ADDENDUM #1

2 RECYCLED ASPHALT
C5.1 NOT TO SCALE

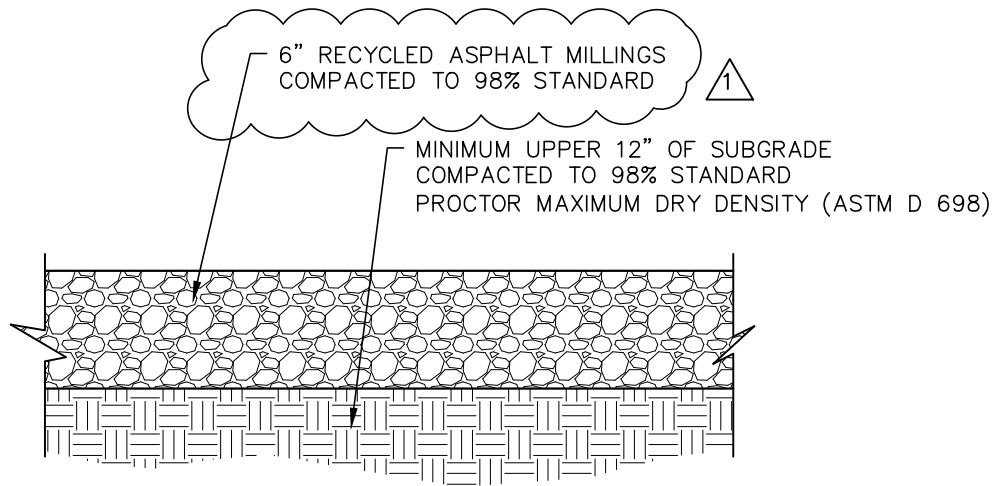
- 2 Sheet C5.1: Replace detail 2/C5.1 Recycled Asphalt with the revised detail included in this addendum.
- 3 Sheet E0.1 The following are manufacturers and catalog numbers of products submitted for prior approval that are acceptable for bidding:
